SUNDRY NOTICES AND REPORTS ON WELLS

2 Name of Operator
Chevron MidContinent, L.P.

8 Well Name and No
Rincon Unit #412

CHANGE OF PLANNED FACILITIES

SITE PLAN

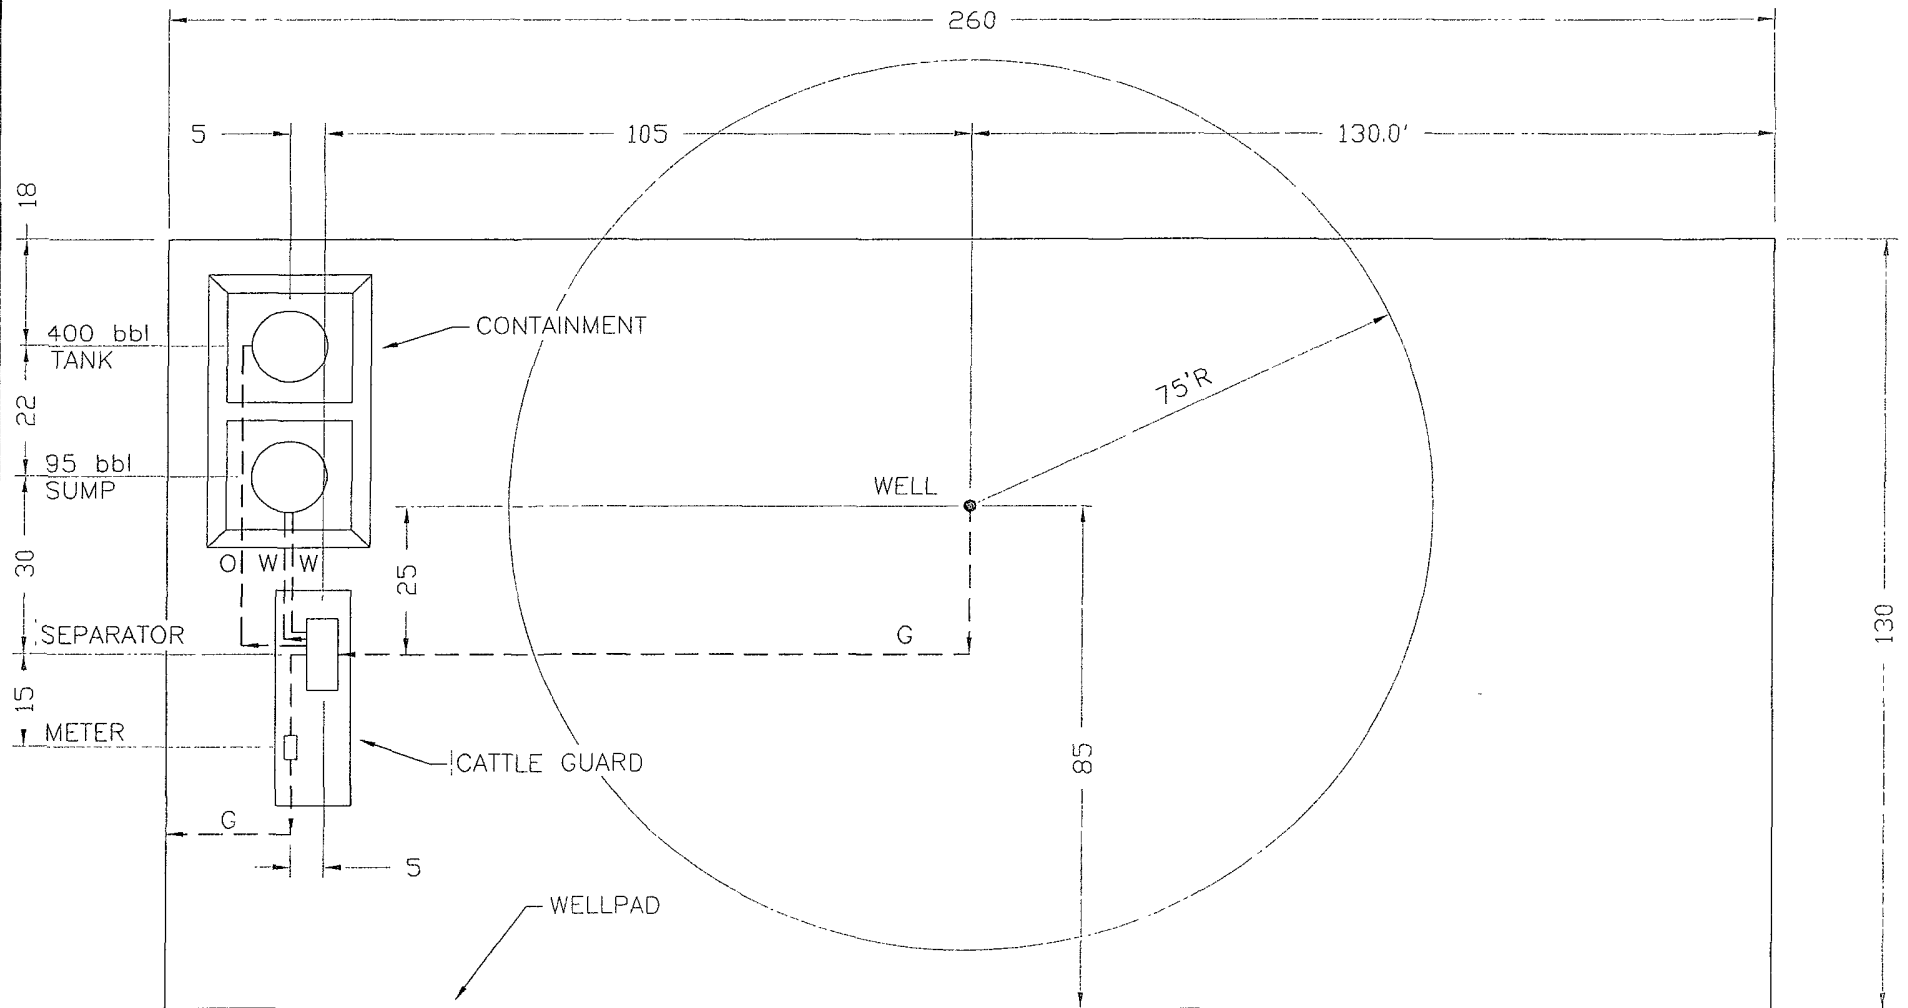
Chevron MidContinent, L.P. reports that we have changed our planned facilities for the above mentioned location. A ~400 BBL steel tank, a ~95 BBL below-grade steel tank, a separator, and an Enterprise meter run will be installed on the well pad. Attached is a basic diagram of how these facilities would be arranged on a wellsite and a basic diagram of the 95Bbl below-grade steel tank. Should you have any questions or require any additional information, please feel free to contact us at anytime.
